# Access Compliance Report

## Public Rights-of-Way

### (Curb Ramps)

Intersection ID: 47646	Main Street: ALDWYCH_WY	Cross Street: DESHLER_MORRIS_LN	Location: SE
ADA ID: 8A2BBB78F3D9	Ramp Type: Perp	Initial Pass/Fail: Fail	Overall Compliance: No
			Severity Score: 21.25

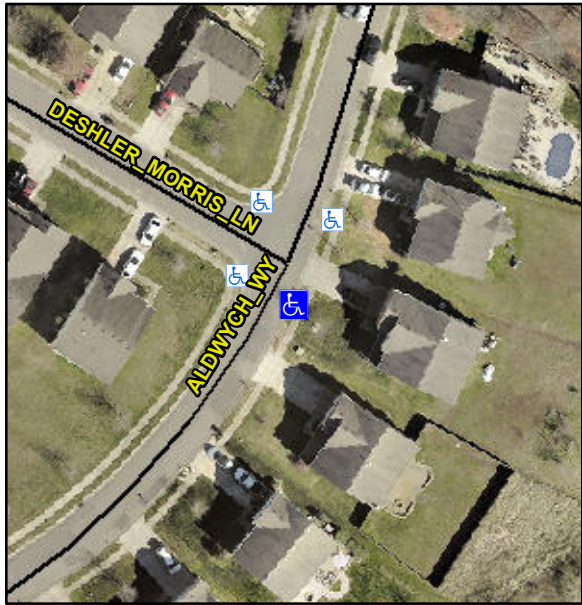
Codes/Mitigation Info/Possible Solution			Field Measurements/Component Compliance					
	Possible Solutions:		Compliance	Description	Data	Compliance	Description	Data
	Remove & Replace Entire Ramp.		N/A	Ramp Length (in)	47.0	Yes	Ramp Slope (%)	7.1
			No	Ramp Width (in)	47.5	No	Ramp XSlope (%)	5.7
			N/A	Flare Type LT	N/A	N/A	Flare Type RT	N/A
			N/A	Flare Slope LT (%)	N/A	N/A	Flare Slope RT (%)	N/A
			N/A	Flare Traversable LT?	N/A	N/A	Flare Traversable RT?	N/A
			N/A	Landing Length (in)	N/A	N/A	DWS Provided?	N/A
			N/A	Landing Width (in)	N/A	N/A	DWS Contrast?	N/A
			N/A	Landing Slope (%)	N/A	N/A	DWS Length (in)	N/A
			N/A	Landing X Slope (%)	N/A	N/A	DWS Full Width?	N/A
Surveyor Notes:		N/A	N/A	Landing Curb? (Y/N)	N/A	N/A	DWS Offset (in)	N/A
PROW/ADA:		Not Found, R304.5.1, R304.5.3	N/A	Shared Landing?	N/A	N/A	Gutter Ponding?	N/A
			N/A	Gutter Lip Ht (in)	N/A	N/A	Gutter Slope (%)	N/A
			N/A	Painted X Walk1?	No	N/A	Gutter X Slope (%)	N/A

X Walk 1 Direction	To NW	N/A	Painted X Walk2?	N/A
			N/A	X Walk 1 Width (in)	N/A	N/A	X Walk 2 Direction	N/A
				X Walk 1 Slope (%)	2.7		X Walk 2 Width (in)	N/A
				X Walk 1 X Slope (%)	6.7		X Walk 2 Slope (%)	N/A
			N/A	Ramp inside XWalk1?	N/A	N/A	X Walk 2 X Slope (%)	N/A
				Road Slope (%)	N/A	N/A	Ramp inside XWalk2?	N/A
				Road X Slope (%)	N/A	N/A	Clear Space?	N/A
			N/A	Any Obstructions?	N/A	N/A	Clear Space to XWalk (in)	N/A
				Obstruction Type		N/A	Storm Grate/Utility Hazard?	N/A
						N/A	Storm Grate/Utility Type	
						Yes	Surface Condition? (G/P)	Good
Total Cost:		\$ 1850.00						
Street 1 Name		ALDWYCH WY						
Stop Condition-Street 2		None						
Street 2 Name		N/A						
Stop Condition-Street 1		N/A
